## Discussions and Replies – Session VI

# DISCUSSIONS AND REPLIES

## SESSION VI

Fig. 1. Computed and Recorded Absolute Acceleration Responses of the Solid Phase in the Up/Downstream Direction at the Crest of the Santa Felicia Dam and the respective Fourier Amplitude Spectra (the computed response is plotted with a solid line)

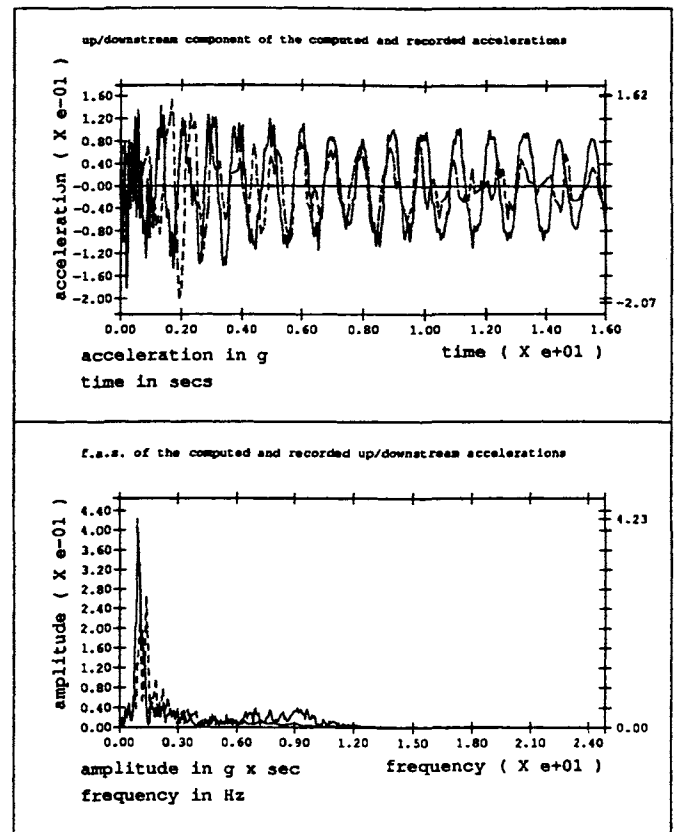
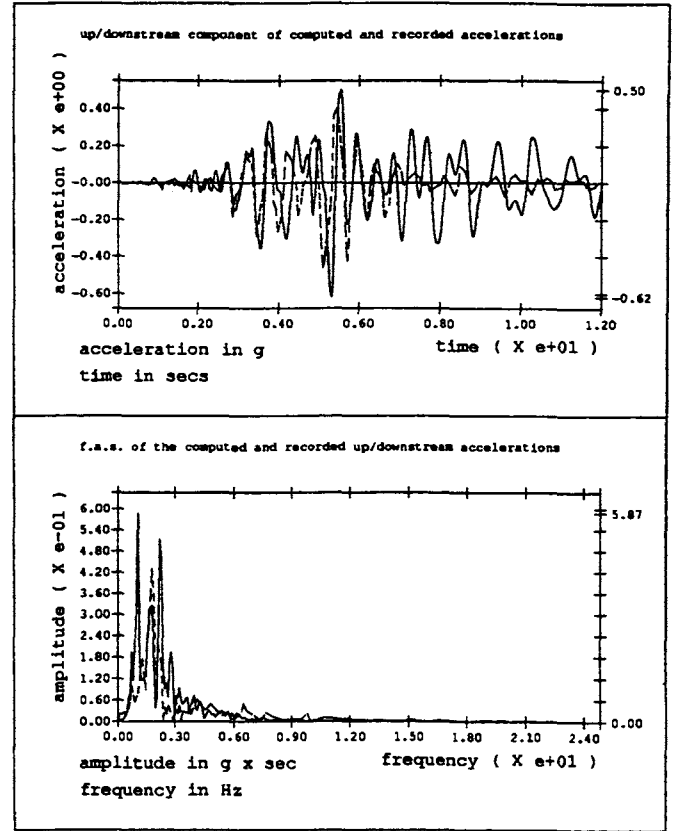
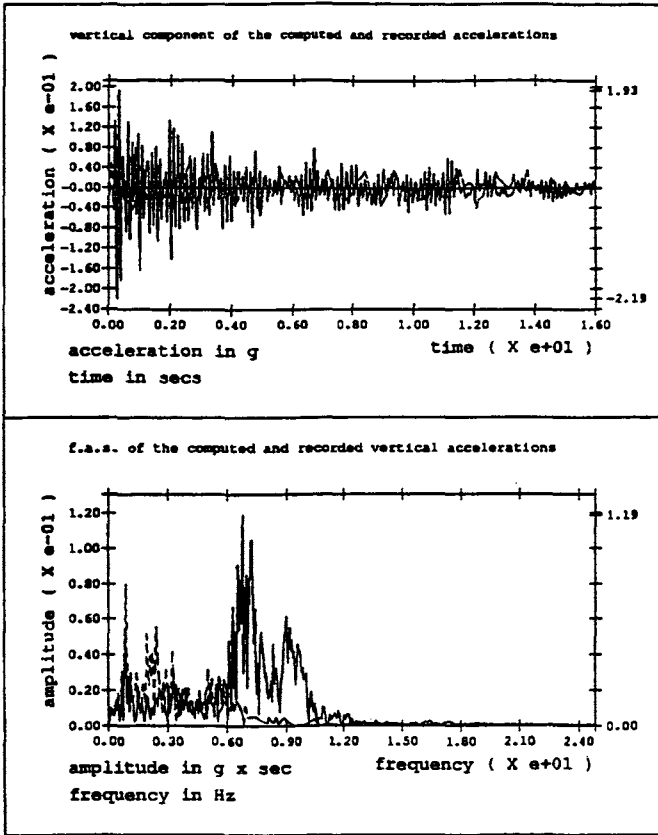
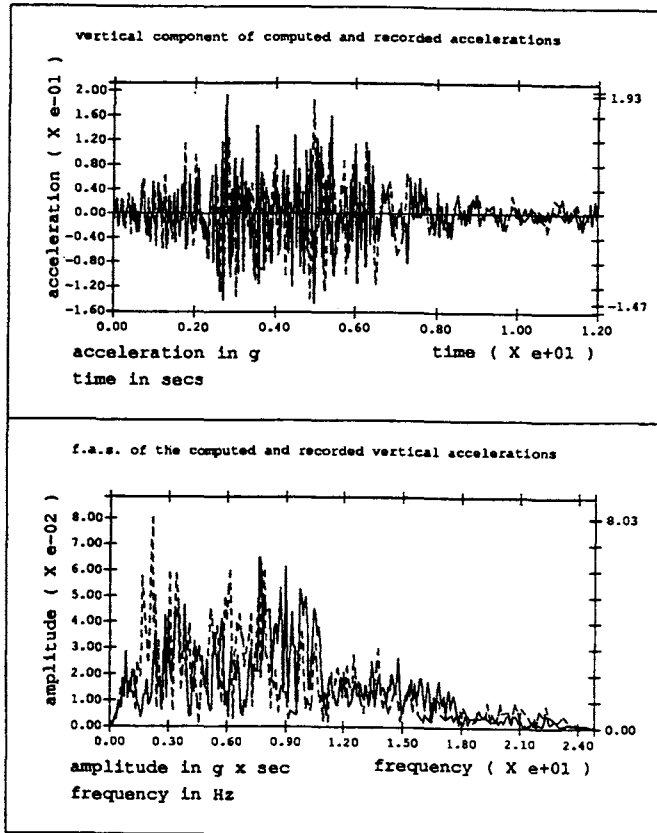
- In order to properly compare the computed and the observed accelerations it is very useful to use Density power spectral functions or Fourier Transform functions. Could the author present this type of graphics for both horizontal and vertical direction in the Santa Felicia and Long Valley Dams?

- The Fourier Amplitude Spectra of the computed and recorded absolute acceleration responses in the horizontal and vertical directions at the crests of the Santa Felicia and Long Valley Dams are given in the following along with the respective computed and recorded absolute accelerations.

Fig.1 N-value at dam body of upstream side ( Boring No. B-2)

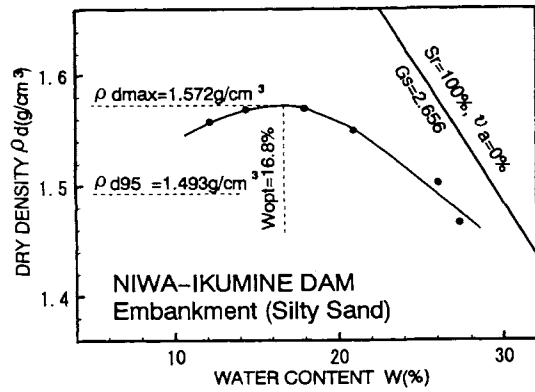
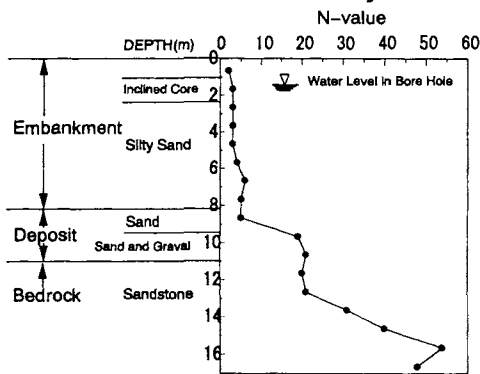
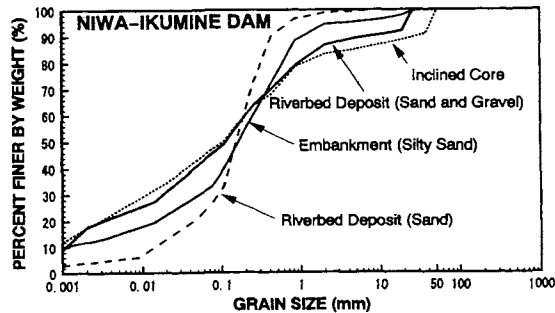
The paper provides some glimpse of the current Specifications of Highways and Bridges of Japan (1990) to calculate a safety factor against liquefaction. This gives an indication of the Japanese approach for determining zones that have potential for liquefaction triggering. The formula appears to be somewhat empirical and conservative considering a large fine content (FC) of 40% as the separating factor of two levels of resistance. Normally this order of fines in sand material would inhibit any strain softening or liquefaction. However, for the Niwa-Ikumie Dam the authors have shown that the embankment soils (silty sand) at depths from 2m to 9m liquefied and this has caused some settlement in the upstream slope. It appears that the liquefaction was mainly dictated by the very low N-values. The authors could have enhanced the quality of the paper by providing more detail on the observations and investigations such as grain size distribution of the embankment and foundation soils and profiles of N-values.

We apologize for in sufficiency of detail on the investigations for Niwa-Ikumine Dam. We supply more detail information on the drilling inspection and soil tests for Niwa-Ikumine Dam. Figure 1 shows the distribution of N-value by the drilling inspection at the dam body of upstream side. Figure 2 shows the distribution of grain size of embankment soil and deposit on riverbed. Figure 3 shows the result of compaction tests of embankment soil consisted in silty sand.
